Well Name: ROUNDY ROUND
FEDERAL COM

Sundry ID: 2855740

Type of Action: Plug and Abandonment

Form 3160-5
(June 2019)UNITED STATES
DEPARTMENT OF THE INTERIOR
BUREAU OF LAND MANAGEMENTFORM APPROVED
OMB No. 1004-0137
Expires: October 31, 2021**SUNDRY NOTICES AND REPORTS ON WELLS**
Do not use this form for proposals to drill or to re-enter an abandoned well. Use Form 3160-3 (APD) for such proposals.

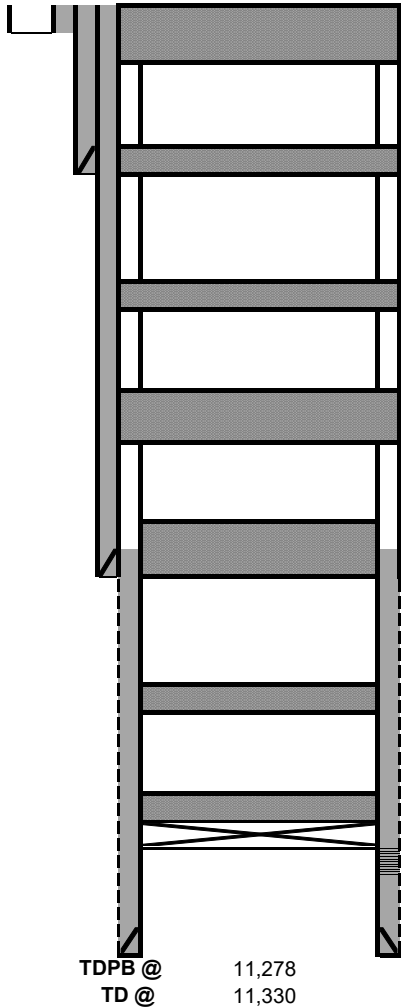
REVISED

Plug #5: Perf & Sqz 72 sxs class C cmt @ 4,662-4,334'. (Bone Springs) **WOC and Tag**
(47 sxs outside, 25 sxs inside)

Plug #3: Spot 45 sxs class H cmt w/ 2% CaCl @ 8,480-7,850'. WOC & Tag @ **min 8144'** (7" Shoe, Wolfcamp, 3rd Bone Spring)

Plug #2: Spot **42** sxs class H cmt @ 10,**102-9592'**. (Atoka & Strawn) **WOC and Tag**

Plug #1: Set 4 1/2" CIBP @ 10,990'. Spot **34** sxs class H cmt @ 10,990-10,**584'**. **WOC and Tag.**

***Run CBL from CIBP to surface.**

Submit results to BLM.

Created By	Condition	Condition Date
gcordero	#5. Atoka plug must be from 10240'	8/7/2025
gcordero	#9. Bone Springs Perf & Squeeze 4662' - 4550'	8/7/2025
gcordero	A Cement Bond Log (CBL) is required to be submitted to electronic permitting.	8/7/2025
gcordero	Submit Cement Bond Logs (CBL) prior to submittal of C-103P.	8/7/2025

Author: JJC

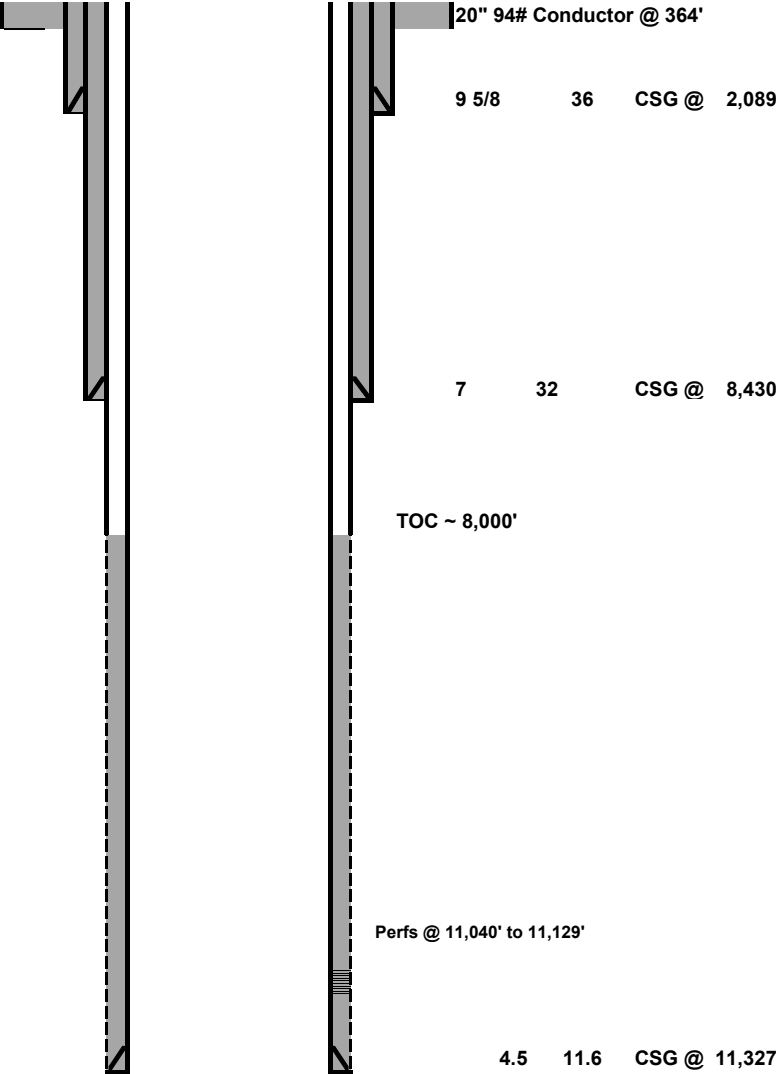
REVISED
